# Modification of Development Consent

**Modification Application:** SSD 7698 MOD 1

Amended site boundary and site layout

**The Land:** Lot 1 DP 874109, 1a McIntosh Drive, Mayfield West

Figure 1

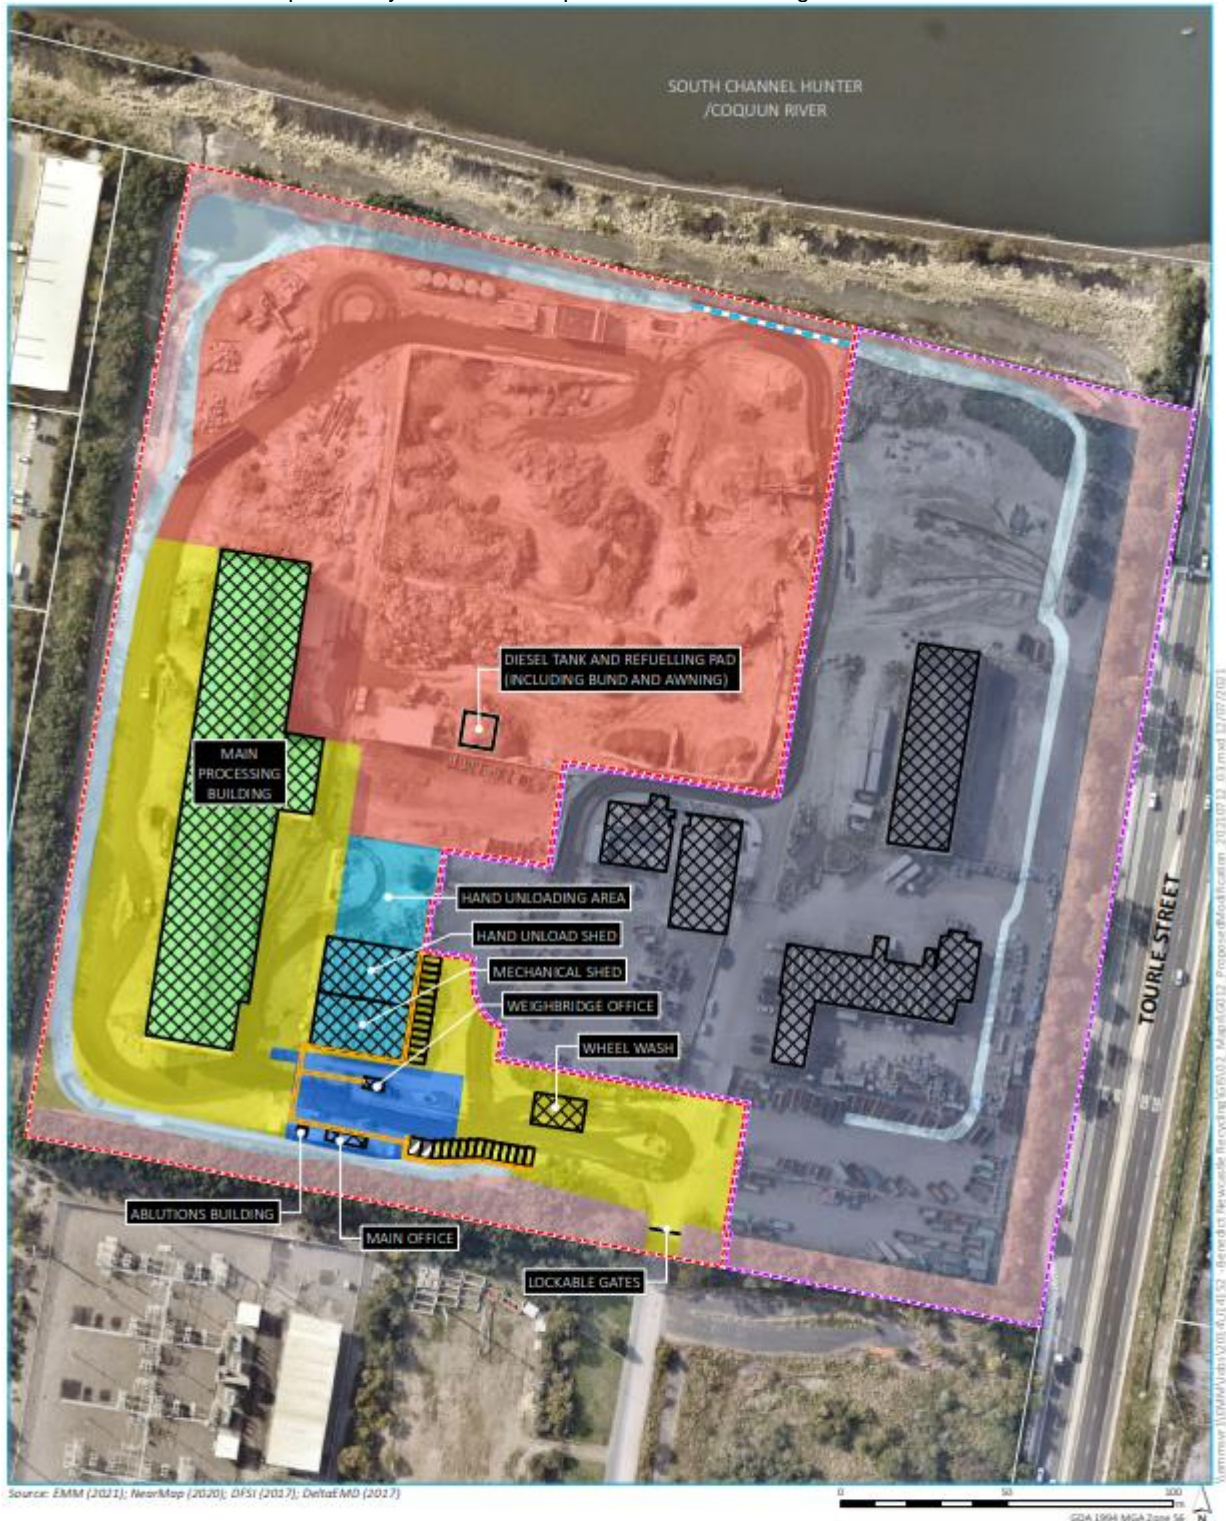
9. Delete the Development Layout Plan and replace with the following:

B32. All hand unloading activities must be carried out in the hand unloading area as shown on the Development Layout Plan in Appendix A. All waste unloaded at the hand unloading area must be unloaded and stockpiled in the hand unload shed or hand unloading area as shown on the Development Layout Plan in Appendix A.
6. Immediately after Condition B32, insert new Conditions B32A and B32B as follows:

B32A. The Applicant must not commence the external unloading or storing of hand unload waste in the hand unloading area as shown on the Development Layout Plan in Appendix A prior to the Surface Water Validation Report (SWVR) in Condition B35 being provided to the satisfaction of the Planning Secretary.

B32B. The hand unloading shed shown on the Development Layout Plan in Appendix A must be fitted with an internal dust suppression system.
7. Immediately after Condition B46, insert new Conditions B46A and B46B as follows:

B46A. The Applicant must ensure a tipping inspector is present in the hand unloading area as shown on the Development Layout Plan in Appendix A when vehicles or customers are present.

B46B. Prior to the commencement of operations under Modification application SSD 7698 MOD 1, the Applicant must amend the bay wall in the heavy waste processing and stockpiling area shown on the Development Layout Plan in Appendix A to accommodate the largest vehicle entering the site to travel unobstructed through the heavy waste processing area.
8. Replace Condition B50(e) with the following:

(e) detail measures to minimise the potential for conflicts between light vehicles entering and exiting the hand unloading area as shown on the Development Layout Plan in Appendix A and heavy vehicles and mobile plant.
